**Independent Advisory Panel to IDB Invest
IAP Report N° 2, April 2019**

**Ituango Hydropower Project
Colombia**

**Independent Advisory Panel to IDB Invest Report N° 2
Ituango Hydropower Project – Colombia, April 2019**

Figure No.5: Reconstruction of the cavity in the area of shafts 1 and 2 (from Integral report, March 2019)

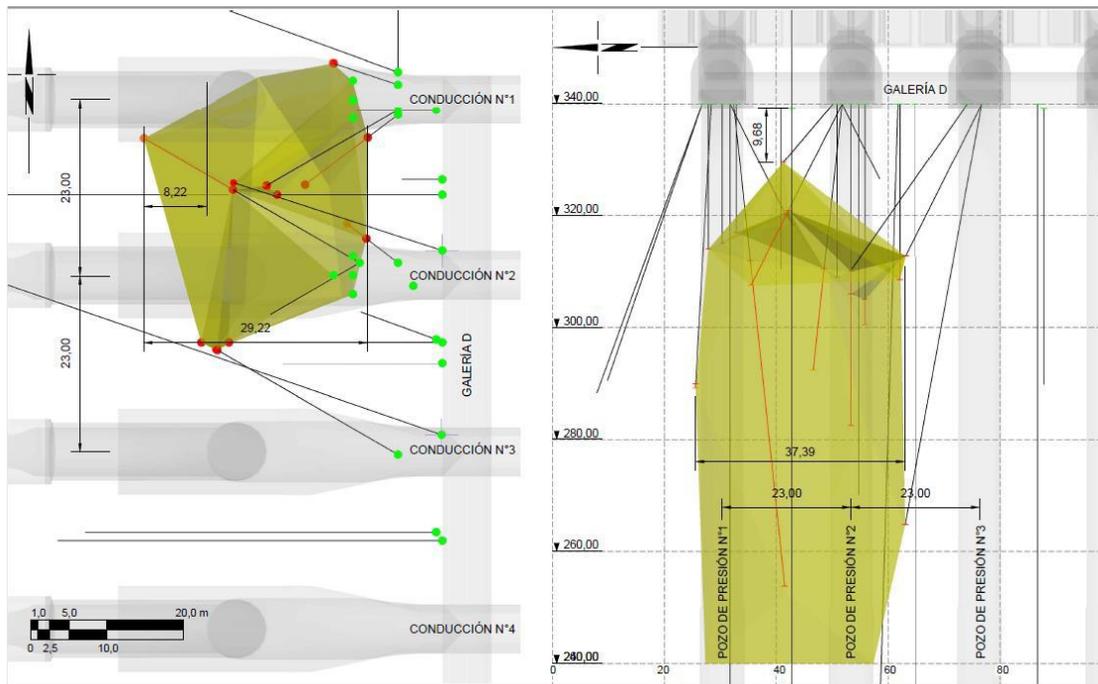
The more severe damages that have been identified to date are in the inlet shafts (see Figure. No.5). Exploratory boreholes revealed that shafts 1 and 2 are severely affected. Sidewall's collapses have caused large voids and certainly created a loose and unstable rock mass at their boundaries. A reconstruction is obviously necessary. Backfilling and grouting to consolidate the surrounding ground should precede shaft reconstruction. Adequate rock reinforcement should be installed as the shafts are sunk. A self-standing steel lining is going to be necessary because no rock mass collaboration can be counted on in withstanding internal pressure during plant operation.

The more severe damages that have been identified to date are in the inlet shafts. Sidewall’s collapses have caused large voids and certainly created a loose and unstable rock mass at their boundaries. A reconstruction is obviously necessary. Backfilling and grouting to consolidate the surrounding ground should precede shaft reconstruction. Adequate rock reinforcement should be installed as the shafts are sunk. A self-standing steel lining is going to be necessary because no rock mass collaboration can be counted on in withstanding internal pressure during plant operation. The Designer will have to check whether full steel lining is required also in all the other shafts. Given the extent of disturbance of the rock mass in the area, that may well be the case.

Figure No.7: Extensive collapse on the almenara norte with direct connection to the PH cavern

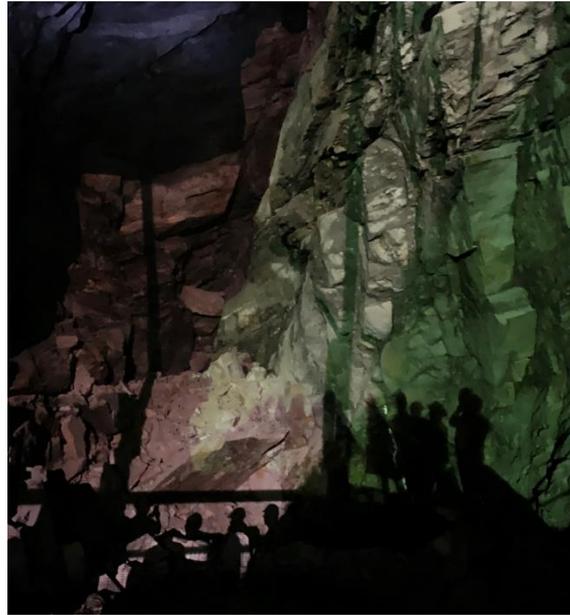
An area of expected massive instabilities is that of the surge chambers (“almenaras”). The limited access revealed extensive failure on the northernmost limit of the “almenara norte” with clear connection to the PH cavern. Most likely, the raging waters found its way to the tailrace through the almenara norte. This resulted in the local collapse of the 30 m wide rock pillar separating PH and surge chamber. Reconstruction will require detailed design and careful mining techniques. Although the current access limitations do not allow full appreciation of the volume involved, it is expected that rehabilitation measures will be of

comparable complexity to those of the pressure shafts 1 and 2. The following figures show the collapse, as visible from “*galería de construcción superior norte*”, and a cross section of the underground openings.

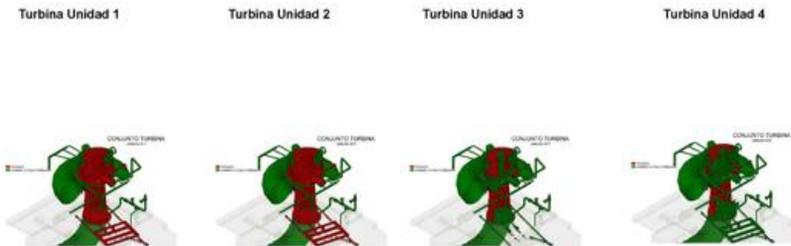
The 10 single-phase HV cable Installed are physically damages and will be replaced.

The isolated phase bus ducts of unit 3 and 4, which are mechanically fragile, are lost.

Figure No.9: Progress in the installation at the time of flooding

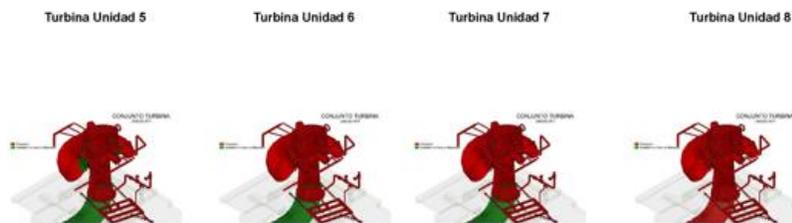
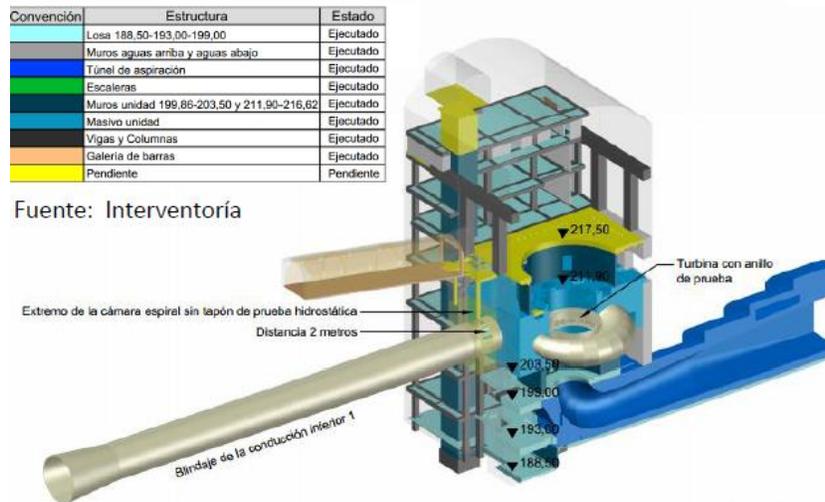
Installation of the north side turbines was well advanced, especially Unit 4 and 3 that were to be commissioned first.

Situation of Unit 4 is unknown being the area covered by debris, but there is room for some optimism for the embedded parts especially the lowest ones.

Unit 2 is in bad conditions and Unit 1 is the most affected. Situation of the draft tubes are little known, and their situation should depend on the length of time the flow of water needed to find an alternative way to flow through the tailrace tunnel.

Figure No.15: Satellite monitoring of the right bank (from Integral 2019)

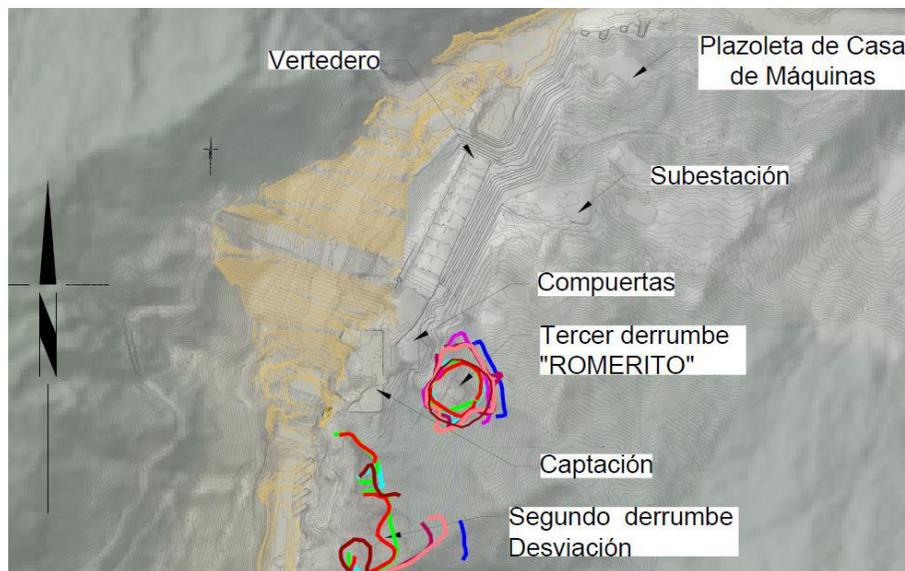
Remote slope monitoring (by satellite) of the slopes around the dam started in July 2018, and it should be extended in the upstream area. IAP recommends adding geodetic targets, piezometers and inclinometers in all benches of the extended treatment.

Figure No.16: Additional grouting in the left abutment (From Integral 2019)

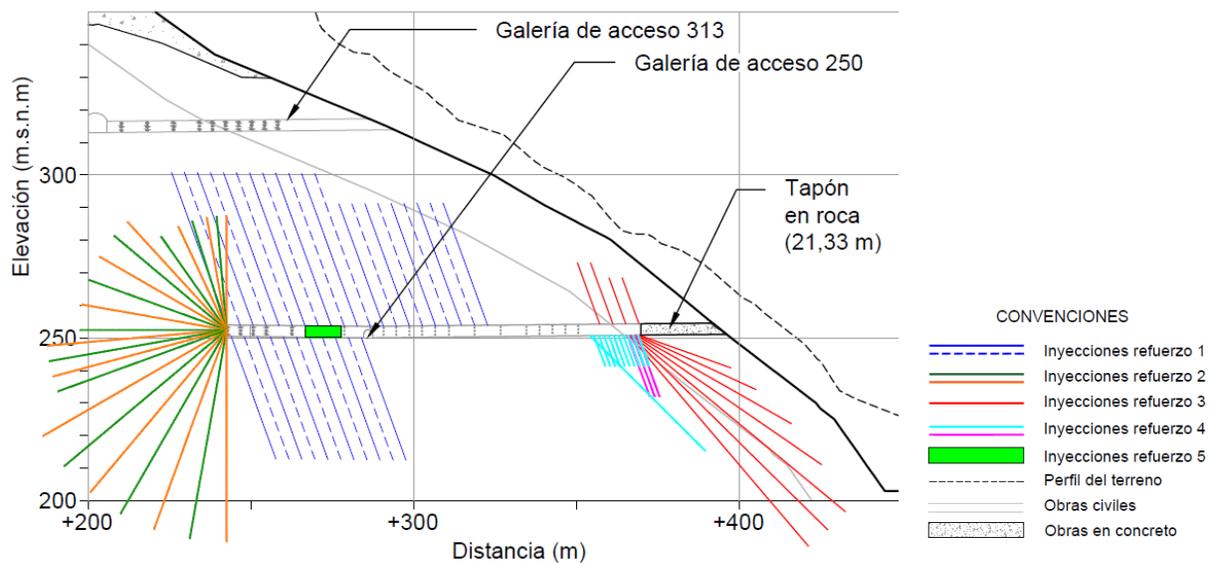
The need of additional grouting works in the left bank was discussed in the IAP's report of September 2018. The origin of such seepage is the left drainage gallery at level +250, where initial curtain grouting holes were not oriented to intercept sub vertical joints. In this abutment total seepage reached 80 l/s. Although not excessive, remedial measures were identified, and additional grouting executed. However overall seepage is today not substantially changed. Currently is reported of about 50 l/s and follows fair well reservoir levels. Additional multidirectional grouting is recommended. All seepage water is reported clean.
